APPENDIX A

BACKDATING INFORMATION

This backdating appendix makes the *7970B/C Digital Magnetic Tape Units Operating and Service Manual*, serial number prefix 1329, applicable to earlier units. Check the serial number prefix of the tape unit on hand and implement the required changes according to the unit changes listed in the table below.

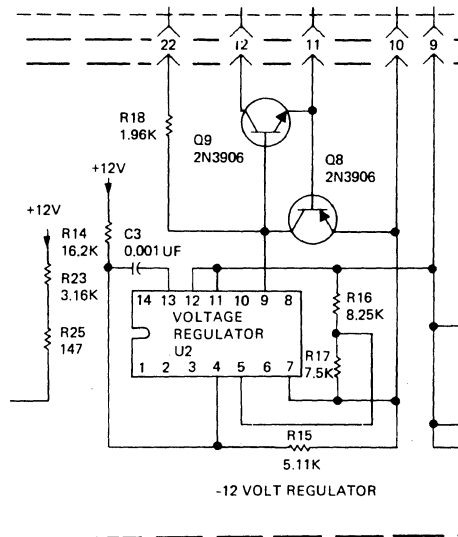
- 82 Part 2, page 7-3/7-4, figure 7-1, power regulator parts location diagram. Delete CR15, CR16, and CR17. Add R17 between R15 and U2.
- 83 Part 2, page 7-3/7-4, figure 7-2, power regulator PC assembly schematic diagram. Change series number of assembly to 1047. Change -12 volt regulator circuit as follows:

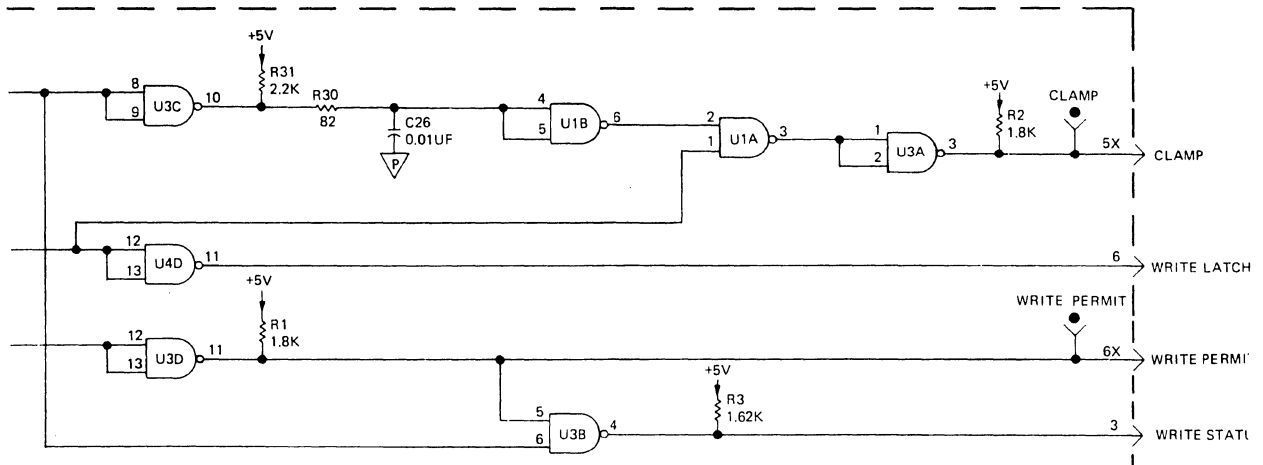
Part 4, page 4-7/4-8, figure 4-5. Change series number of assembly to 1047. Change write latch circuit as shown below.

Figure 2-1. Skew Alignment Waveforms

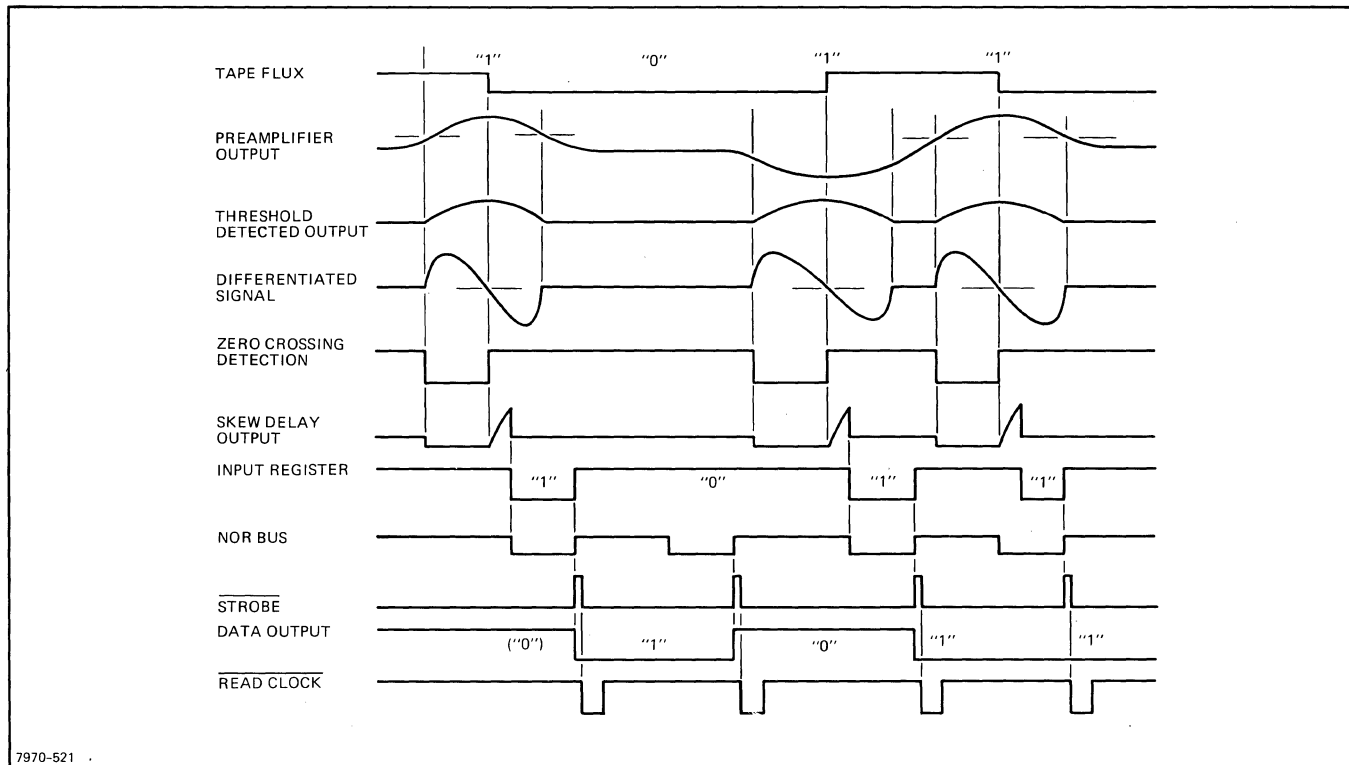
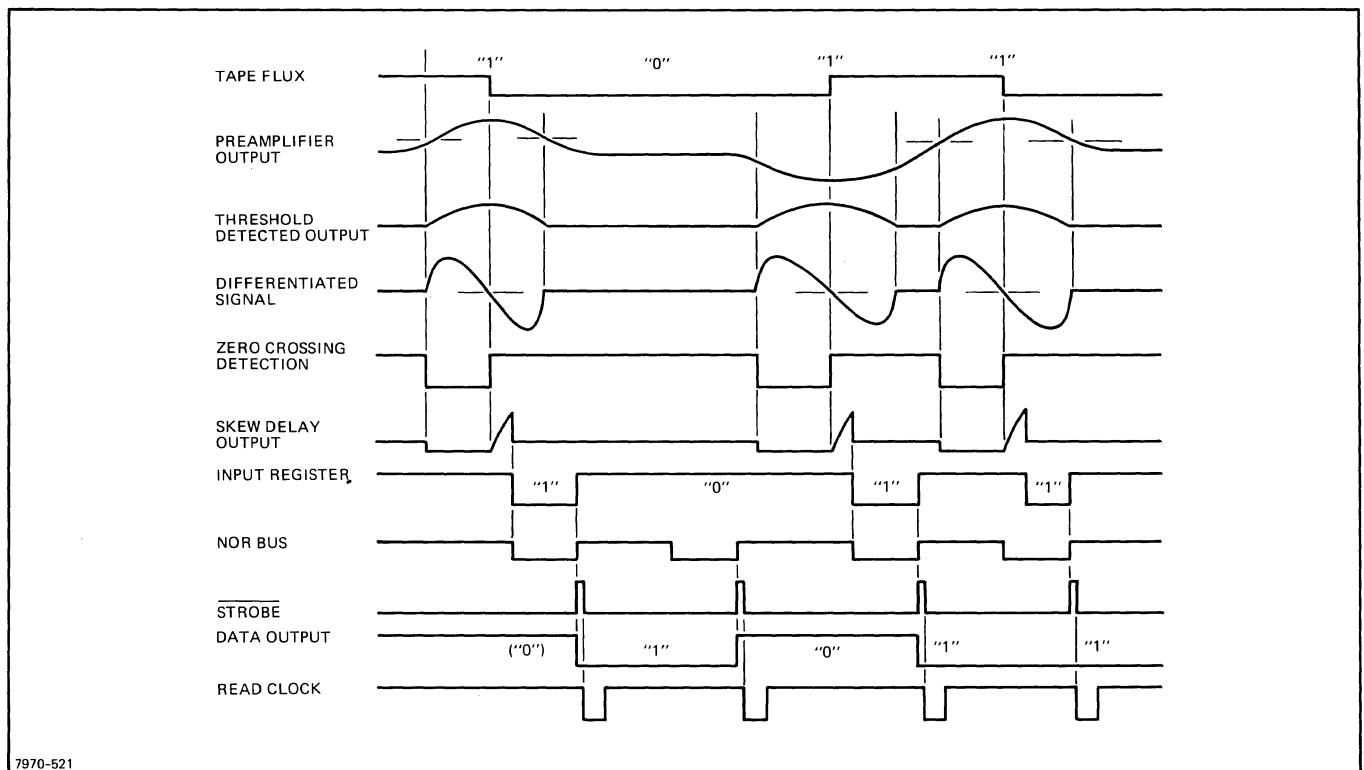
<u>CHANGE</u>	<u>DESCRIPTION</u>
43	Part 3, page 2-4. Replace figure 2-1 with figure 2-1 at the back of this appendix.
44	Part 3, page 1-4, paragraph 1-6. Delete reference to high gain amplifier and the tape speed intervals.
45	Part 3, page 1-2, figure 1-1. Replace figure 1-1 with figure 1-1 at the back of this appendix.
46	Part 2, page 7-7, figure 7-6. <ol style="list-style-type: none">Add line between J5 pin 9 and J3 pin 1; label the line "PSL".Add, in the upper left corner of the PC assembly, part no. 07970-62062, series 1109.
47	Part 2, page 6-8. Delete items 129 through 134.
48	Part 2, page 6-7, item 74. Change item 74 to read: WRITE INTERCONNECT ASSEMBLY A14, part no. 07970-60300.
49	Part 2, page 6-3, figure 6-1. Delete items 129 through 134.
50	Part 1, page 2-12, figure 2-6. Replace figure 2-6 with figure 2-6 at the back of this appendix.
51	Part 1, page 1-1, table 1-2. Delete option 016.
52	Part 2, page 7-9, figure 7-8. <ol style="list-style-type: none">Change resistors A7R49 and A7R52 to 10k.Change resistor A7R50 to 21.5k.Change series no. of Reel Servo PC Assembly to 1102.
